9018 BLAIR RD

Groundwater and Wastewater Services File Imaging Project

# CERTIFICATE OF COMPLETION/OPERATION PERMIT 6400

# INSTALLATION CONSTRUCTION, ALTERATION, AND/OR REPAIR APPROVAL

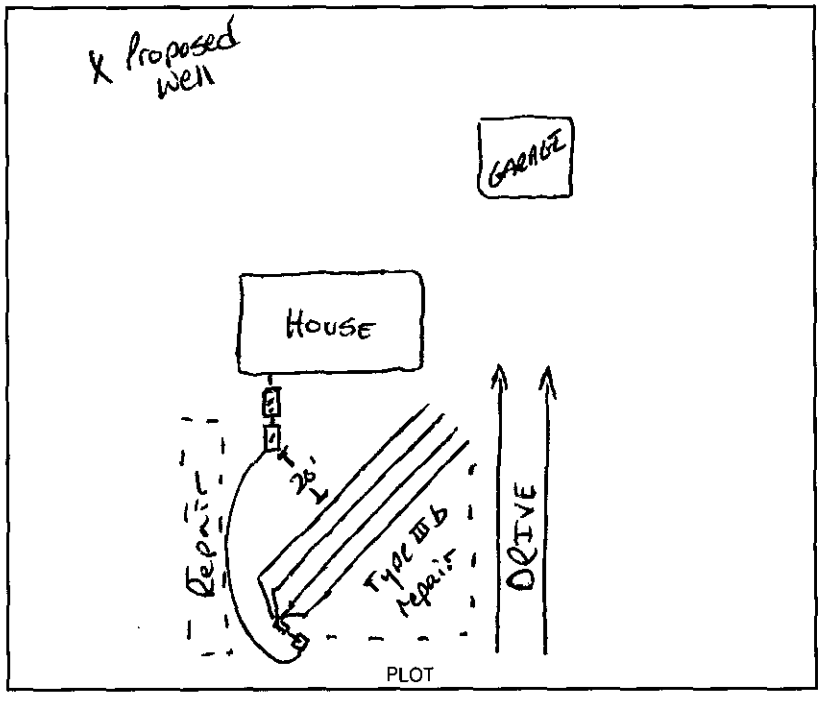
COMMENTS: Type III b Three Bedroom Residence (4) 3'W x 100' x 12"s — System not installed as originally planned. Repair for front right corner of lot would be best utilized if they explore by installing pneumatic ejector and routing washer repair in this area.

PLOT OF SYSTEM

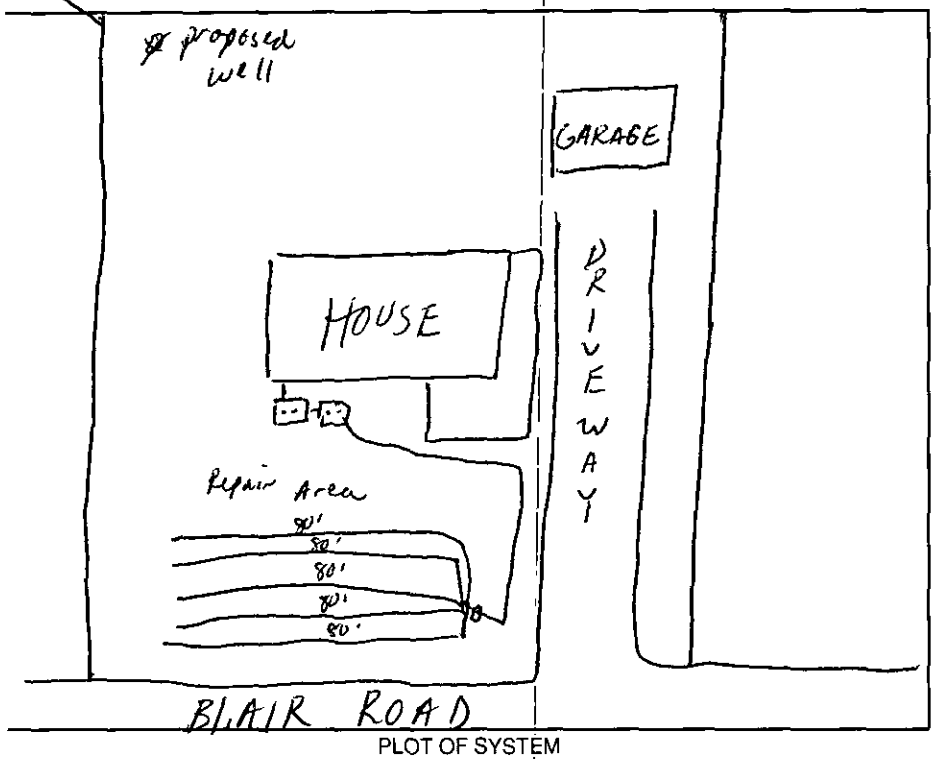
Comments: 1500ST, 1000DT, PI, Gas line must be removed before septic system installation, Lift pump required, 5 line x 80'long x 3'wd x 12" stone Keep septic system > 100' from any wells | Keep drainfield > 15' from 2' cut

# PROPOSED PLOT PLAN

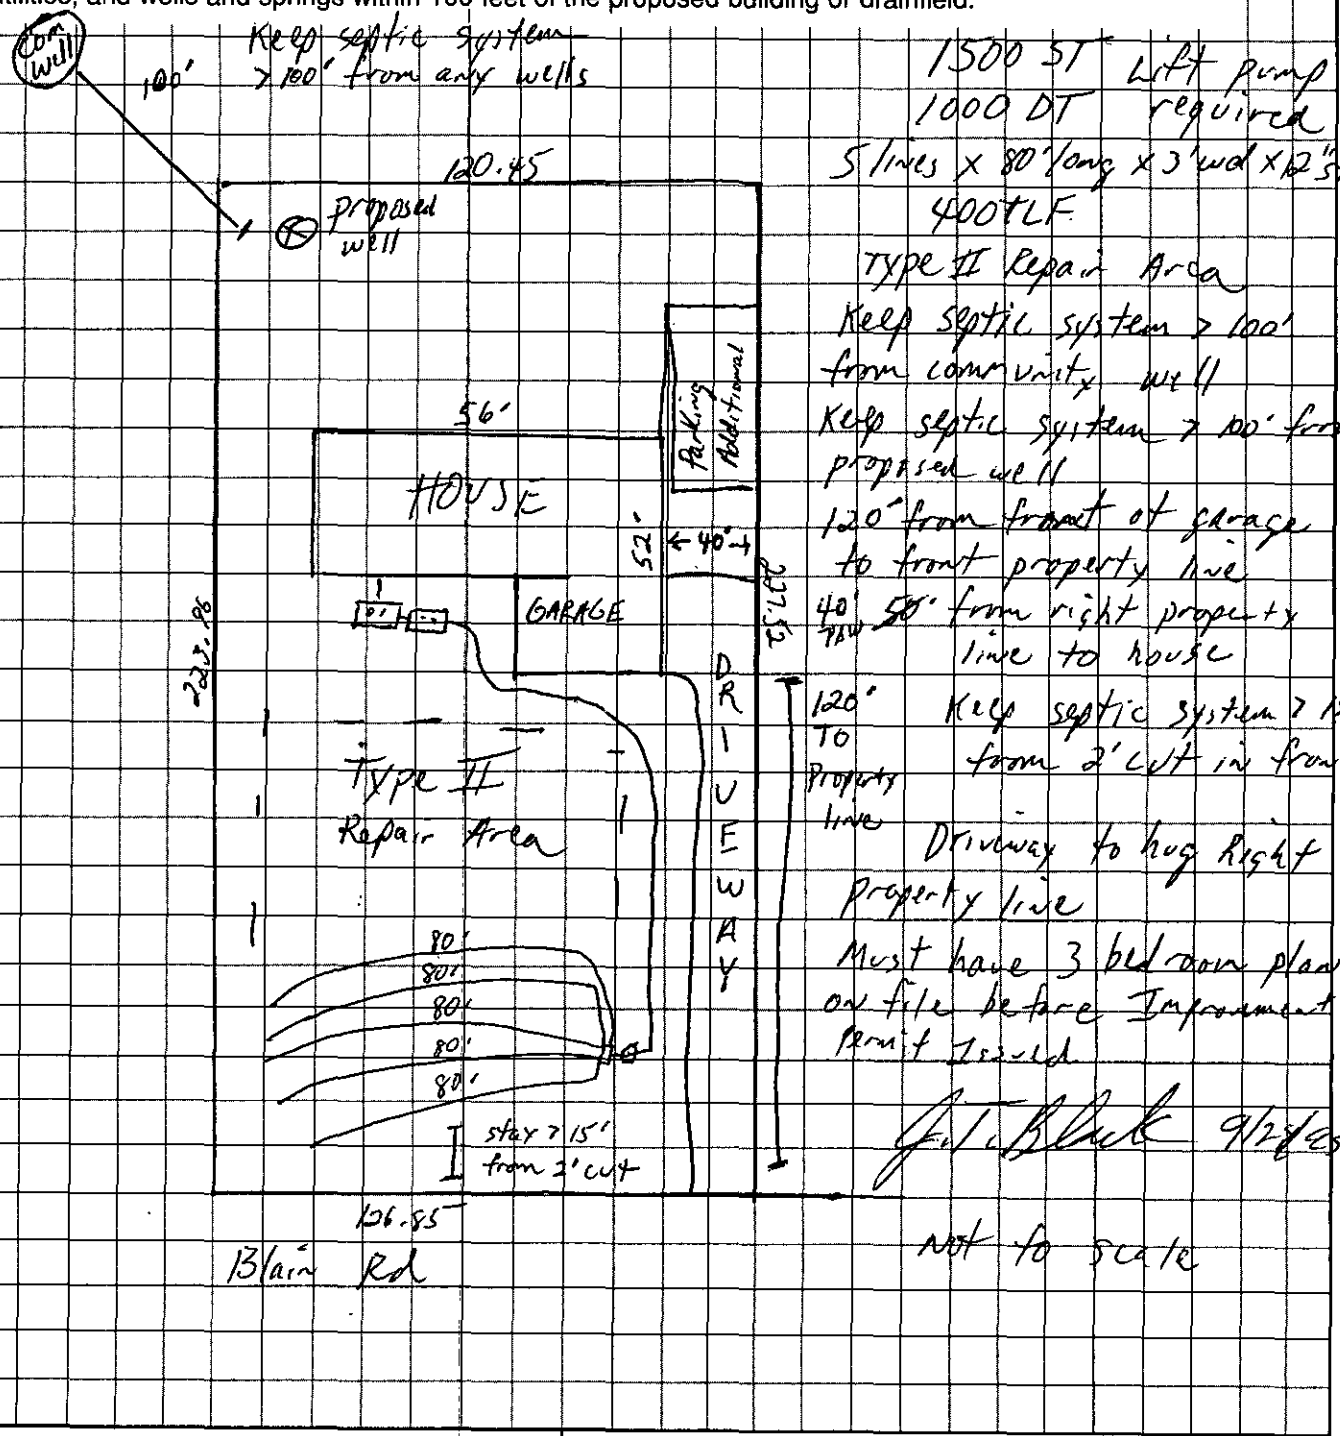
1500 ST Lift pump required
1000 DT
5 lines x 80' long x 3' wd x 12" stone
400 TLF
Type II Repair Area
Keep septic system > 100' from community well
Keep septic system > 100' from proposed well
120' from front of garage to front property line
40 ~~50~~ from right property line to house
120' To Property line
Keep septic system > 15' from 2' cut in front.
Driveway to hug Right Property line
Must have 3 bedroom plan on file before Improvement Permit Issued

**MECKLENBURG COUNTY ENVIRONMENTAL HEALTH**
**SITE EVALUATION REPORT**
**SERIAL NUMBER** 10317

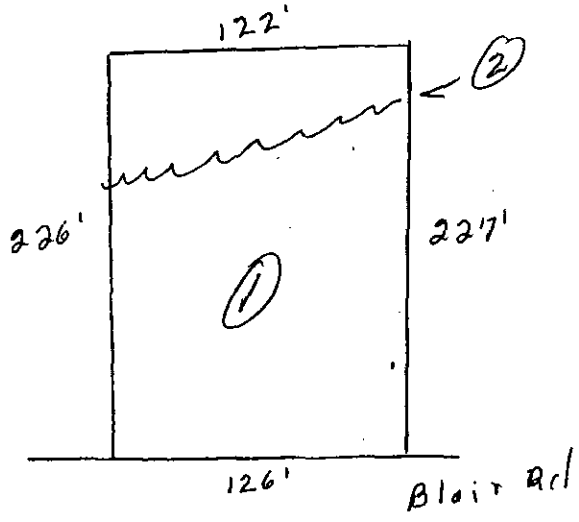
Comments: limited area
